CERTIFICATE OF APPROPRIATENESS

Property: 1911 A Crockett St, Lot 4, Block 1, Barclay Estates Subdivision. The property is a vacant interior lot, subdivided into two lots, Lot A measuring 2,604 square feet (42' x 62') and the Lot B measuring 1,596 square feet (42' x 38').

Proposal: New Construction – Residence

Construct a two and a half-story 2,640 square foot residence and attached garage.

NORTH ELEVATION – FRONT FACING CROCKETT STREET
PROPOSED

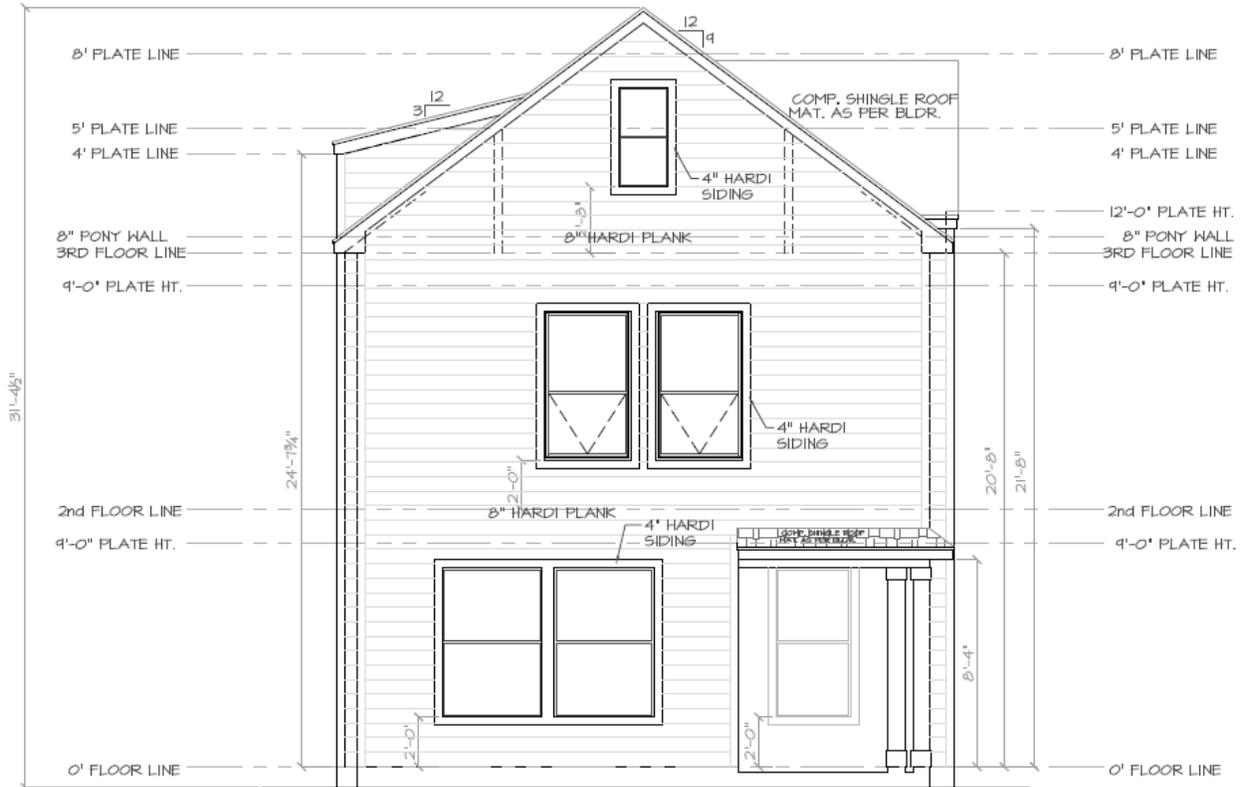
- 8" horizontal lap cementitious siding is not an appropriate feature within the context area. Smooth-finish 4" reveal horizontal lap cementitious siding would be a more appropriate siding option.*

- The width is 25', below the typical dimensions of the contributing structures. The porch and plate heights of the first floor are in scale with the neighboring property at 1907 Crockett. The proposed structure has a third level ½ story tucked under the roof which sits on a pony wall. Although the house retains the appearance of a traditional gable-front two-story residence, this partial 3rd story makes the roof ridge slightly taller than a contributing two-story in the historic district (there are no two-story contributing structures on the blockface).*

SITE PLAN
PROPOSED

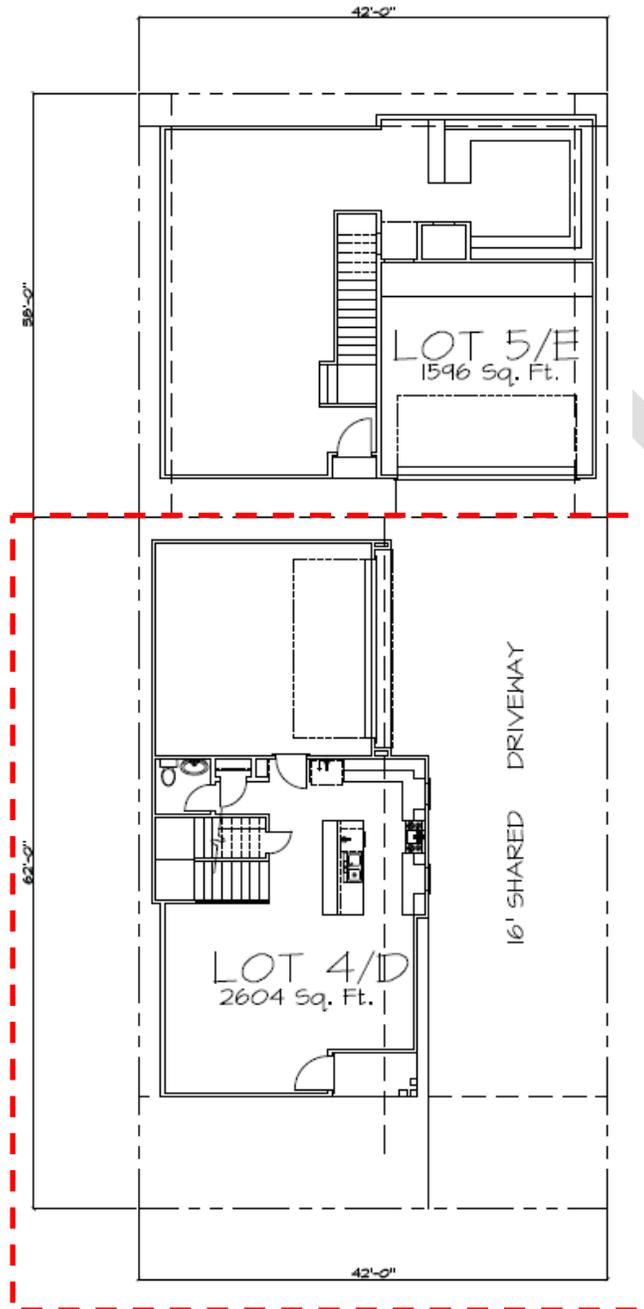
- 1.1. A site plan is required for a COA application. Each of these applications includes a drawing labeled "Site Plan". However, these purported site plans do not indicate the orientation of the proposed buildings to the surrounding streets or to each other. In addition, the elevations are listed as "left", "right", etc. instead of the usual "north", "south" etc. All this is contrary to industry standards, and makes the site plans very difficult to decipher. This needs to be addressed in order to make the proposed plans more readily understandable.

- 1.4. The historic/contributing structure at 1907 Crockett is known to encroach on its neighbor to the west (1913 Crockett). This encroachment is not shown on the site plan. This omission is significant, since it affects the actual distance that will separate the new structure at 1913 from the existing one at 1907.

- 1.5. A 10' setback from the street is noted. This is out of character for the District, where setbacks of 15 feet or more are prevalent on contributing structures. Is this permissible?
